ECE/TRANS/WP.29/GRSP/2006/18
2 October 2006

Working Party on Passive Safety

**PROPOSAL FOR DRAFT AMENDMENTS TO REGULATION No. 16
(Safety belts)**

Submitted by the expert from Japan

"Annex 8

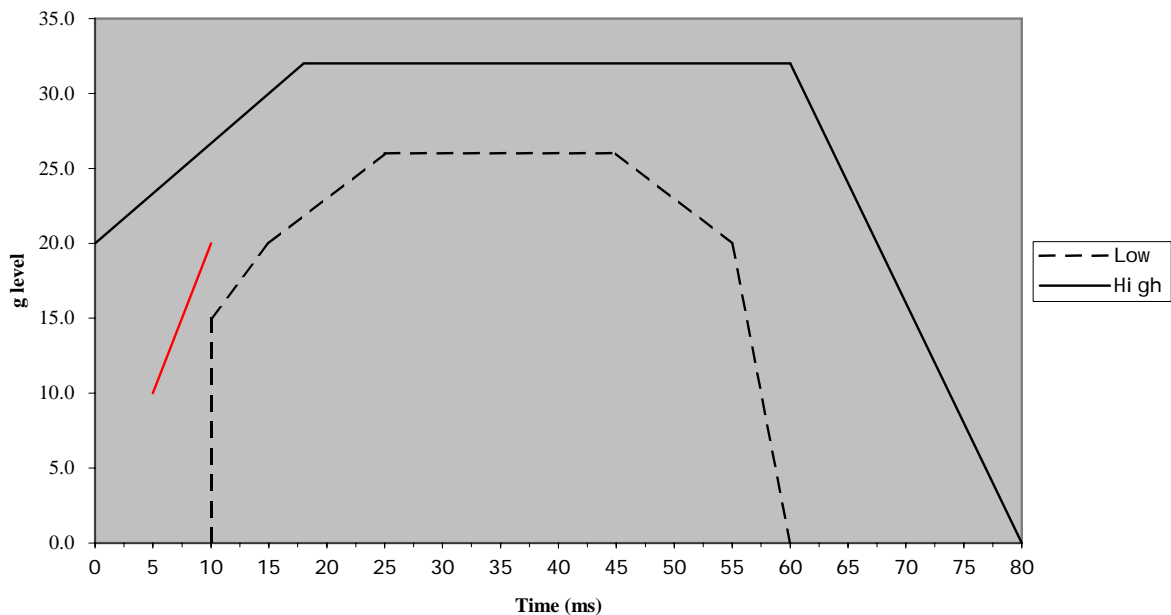
Annex 8, amend to read:

DESCRIPTION OF THE CURVE OF TROLLEY'S DECELERATION OR ACCELERATION,
AS A FUNCTION OF TIME

The additional segment (see paragraph 7.7.4.2.) applies only for the acceleration sled "

The acceleration curve of the trolley, weighted with inert mass, must remain within the hatched area of the graph in Annex 8, and stay above the segment defined by the coordinates 10g, 5 ms and 20g, 10 ms. The start of the impact

(T0) is defined, according to ISO 17 373 (2005) for a level of acceleration of 0.5g. In no case shall the total mass of the trolley and vehicle structure and inert masses differ from the nominal value for calibration tests by more than ± 40 kg. During calibration of the acceleration test device, trolley's total velocity change ΔV shall be $51 \text{ km/h } \begin{smallmatrix} +2 \\ -0 \end{smallmatrix} \text{ km/h}$.
